# **ADDENDUM 1:**

# City of Lawrence KANSAS

**ADDENDUM 4:**  
**Sanitary Sewer Channel**  
**Crossing Requirements**

### SANITARY SEWER CHANNEL CROSSING DESIGN REFERENCE

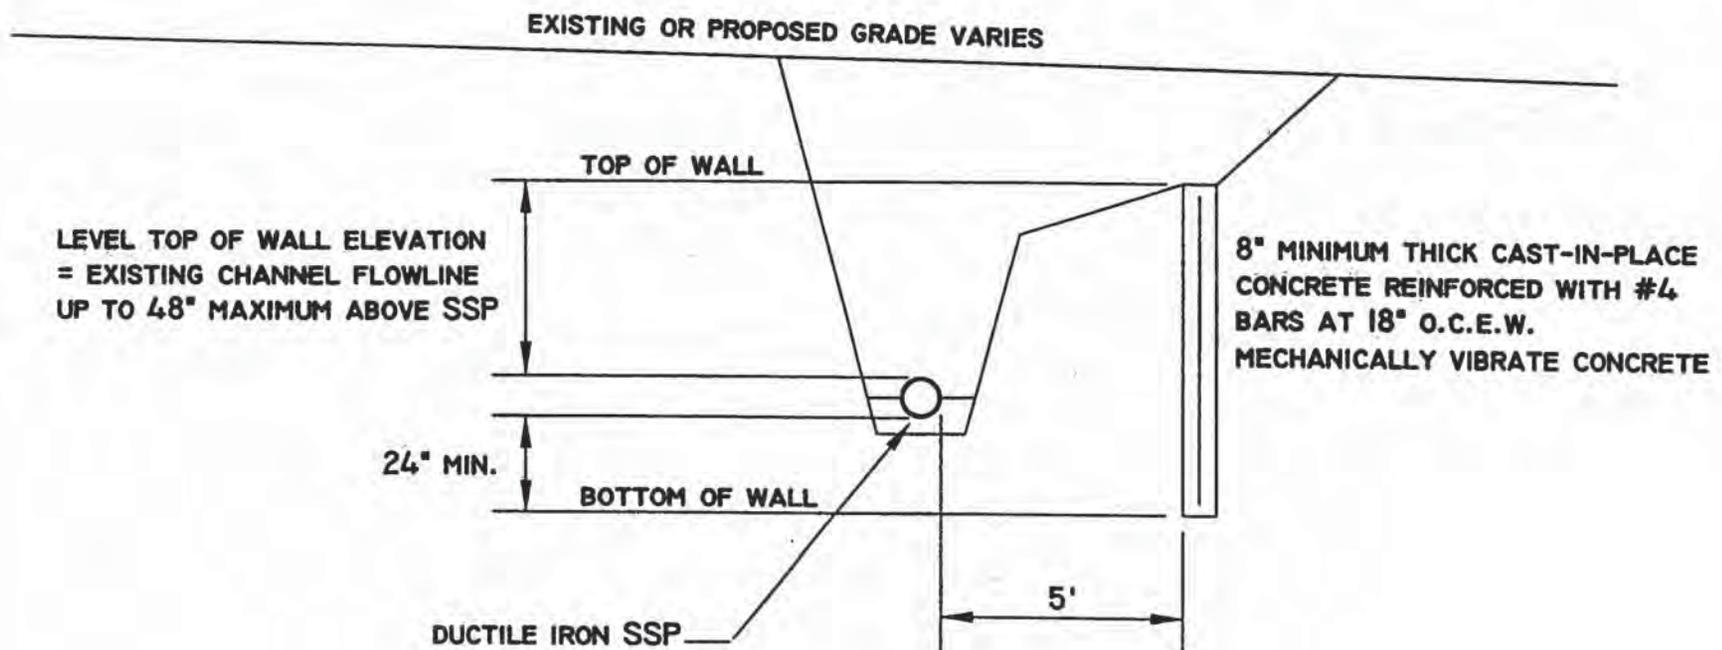
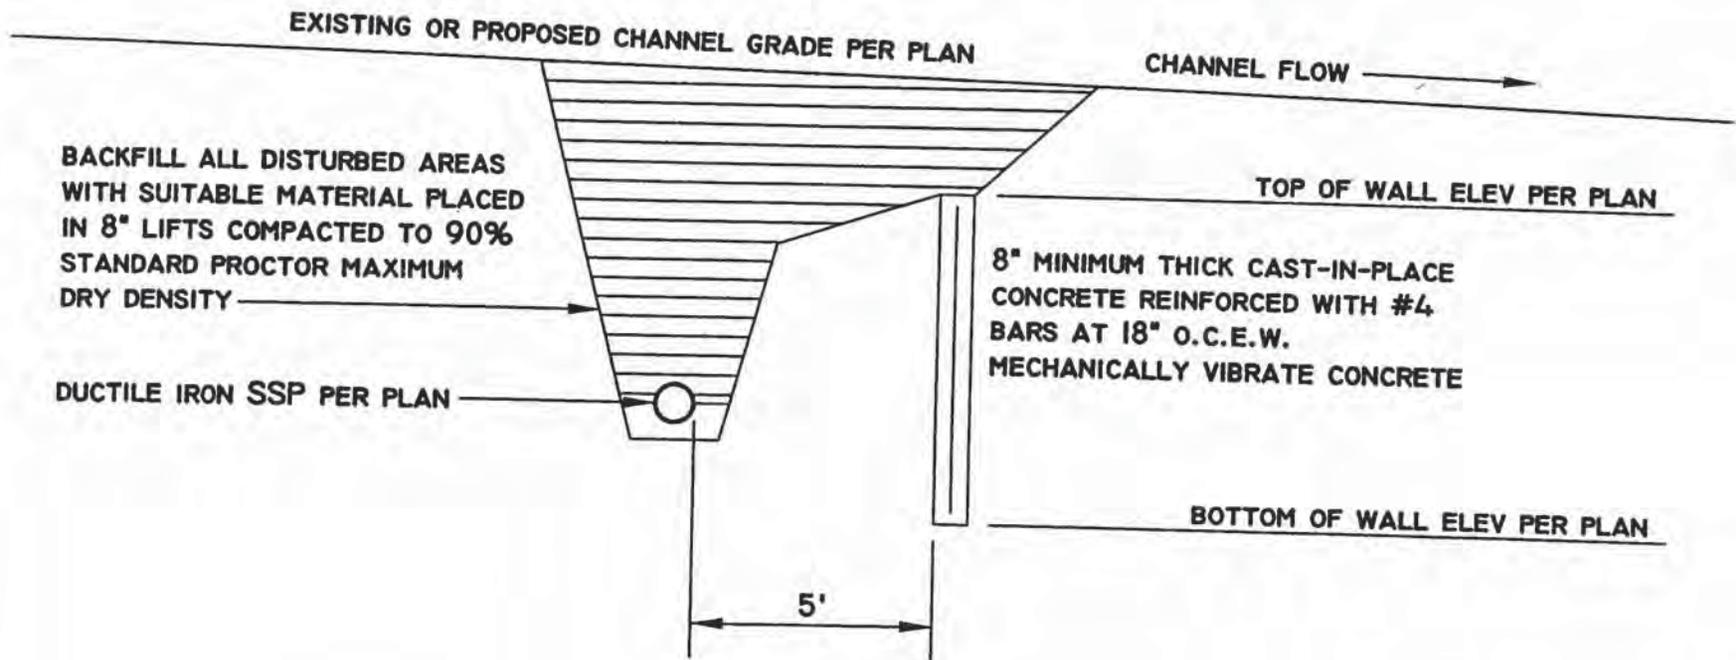
Sheets 1 through 3 attached provide design requirements for channel crossings. The drawing "Erosion Cutoff Wall Typical Section" is included on the enclosed disk.

1. SANITARY SEWER MUST HAVE 30° MINIMUM COVER AT CHANNEL FLOWLINE.
2. SPECIFY EROSION CUTOFF WALL LENGTH, TOP ELEVATION AND BOTTOM ELEVATION ON PLAN VIEW AT ALL CHANNEL CROSSINGS.
3. INCLUDE EROSION CUTOFF WALL TYPICAL SECTION ON PLANS.
